ONSITE SANITATION City of Portland – Bureau of Development Services
1900 SW 4th Avenue, Portland, Oregon 97201 – 503-823-6892 – TTY 503-823-6868 – www.portlandoregon.gov/bds
SEPTIC REVIEW CERTIFICATION (Land Use/Planning)

Address of Proposed Work: 31520 E Woodard Rd, Troutdale, OR 97060

Description of proposed work for this Septic Planning Review Septic system upgrade with more primary tank volume, new treatment system, and drainfield expansion.

Corbett School District
Woodard Campus
31520 East Woodard Road,
Troutdale, OR 97060

GRAPHIC SCALE
0 2 4 6 8 10
DEMOLITION PLAN
SCALE: 1"=20'

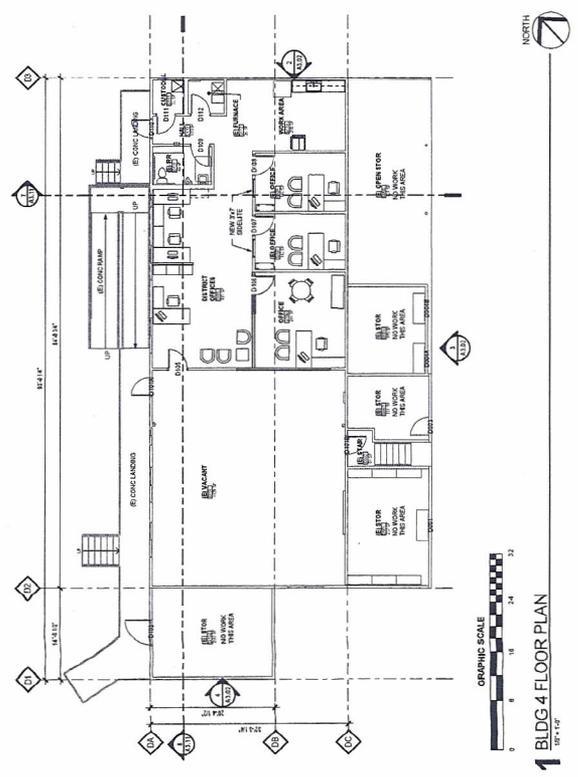
Proposed Woodard School with a maximum occupancy of 175 total occupants (150 students + 25 staff) poses no concern to septic. No showers, gymnasium, or cafeteria are proposed. Primary + replacement drainfield areas must be fenced + protected from demolition + construction activities.

Project: _____
Consultant: _____
Revision: _____
No. Drawings: _____
Date: _____
Sheet No: _____
Project No: _____
20019
Project Name:
**BUILDING 4 FLOOR
PLAN**

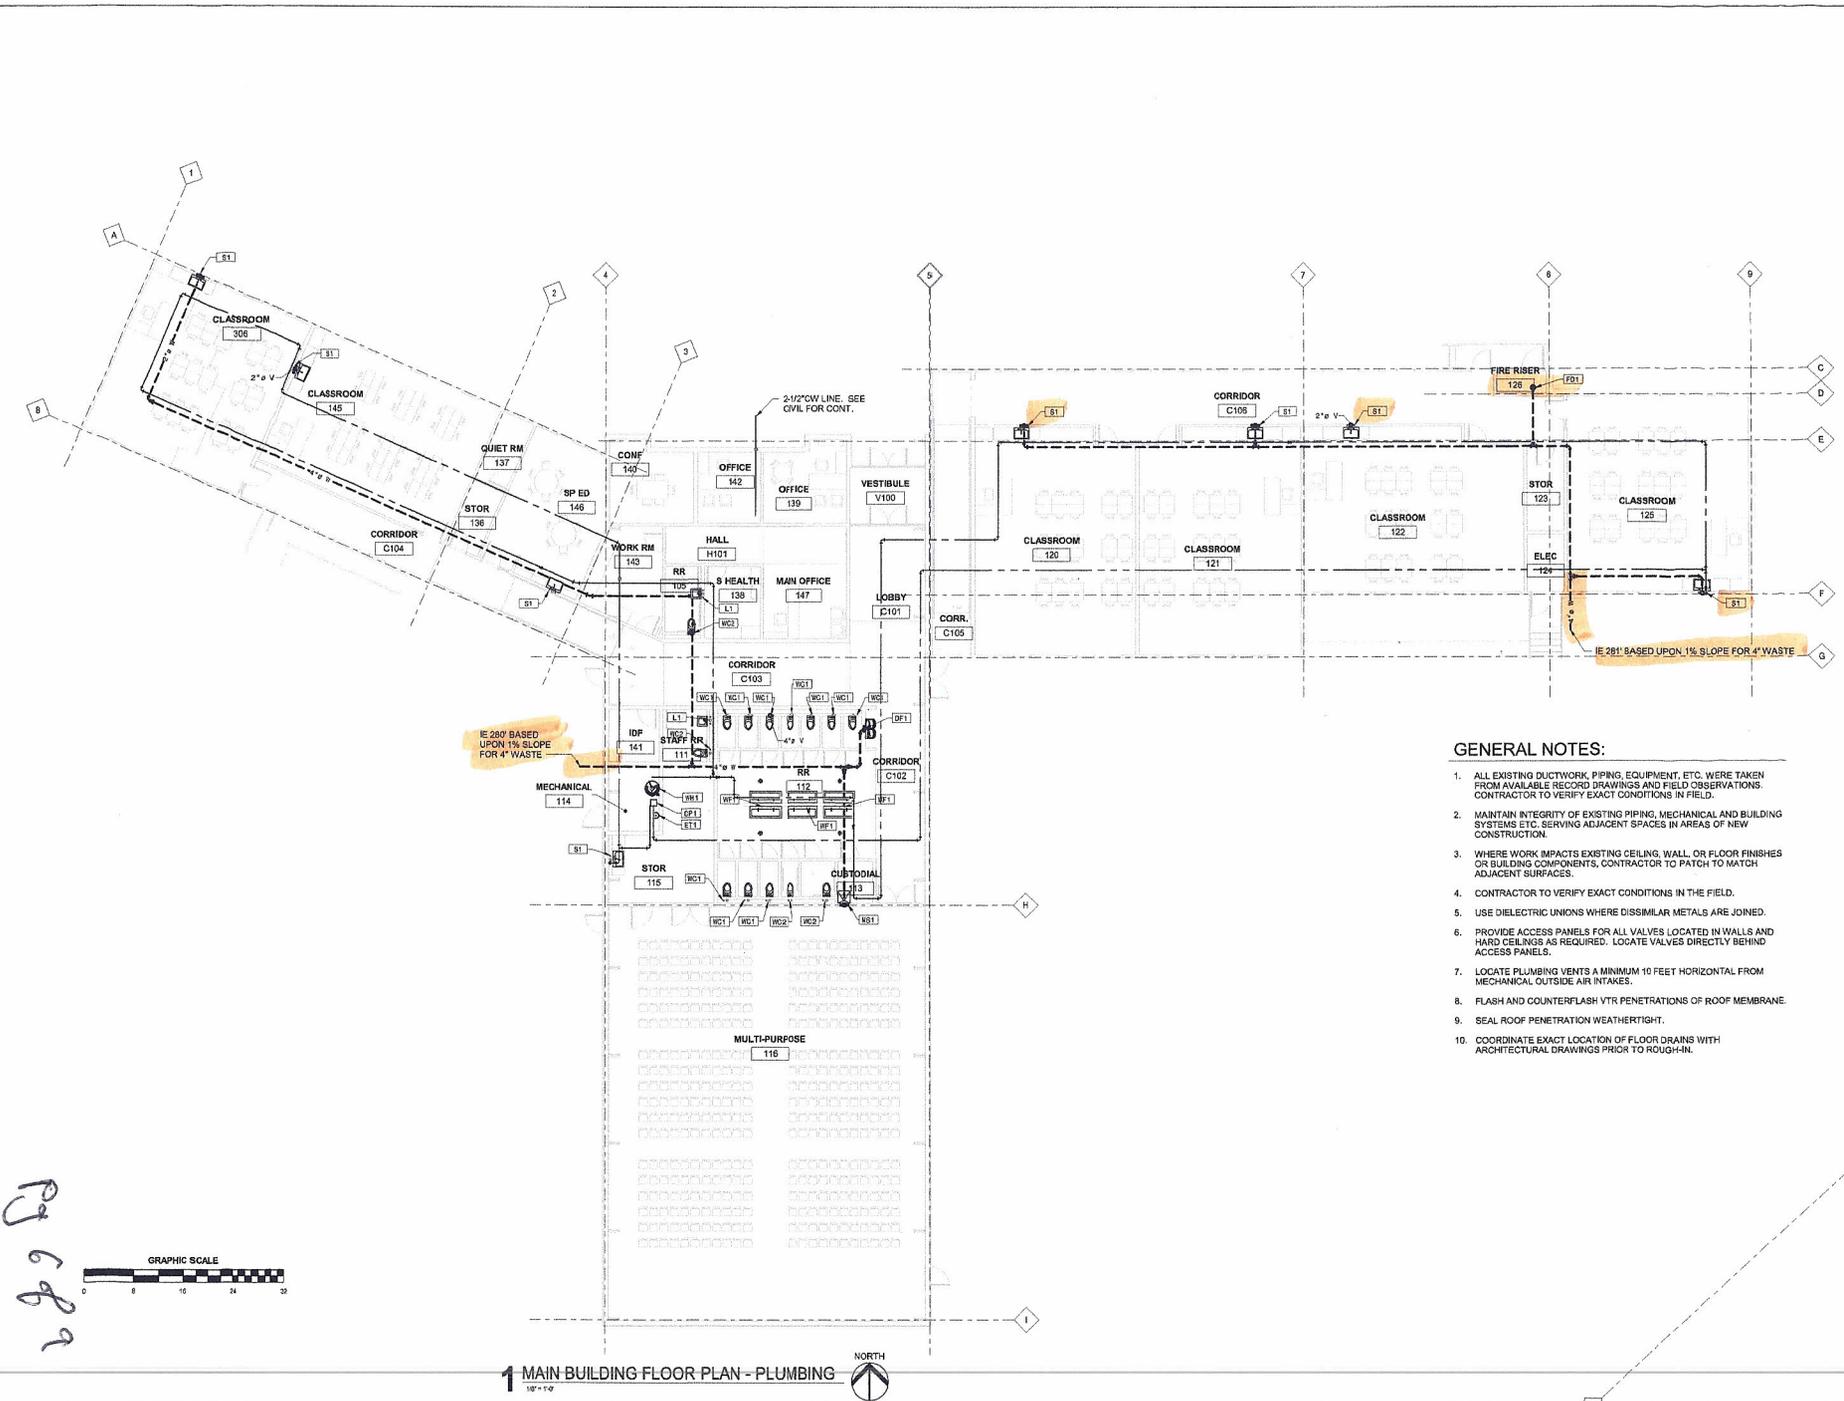
No showers or cafeteria
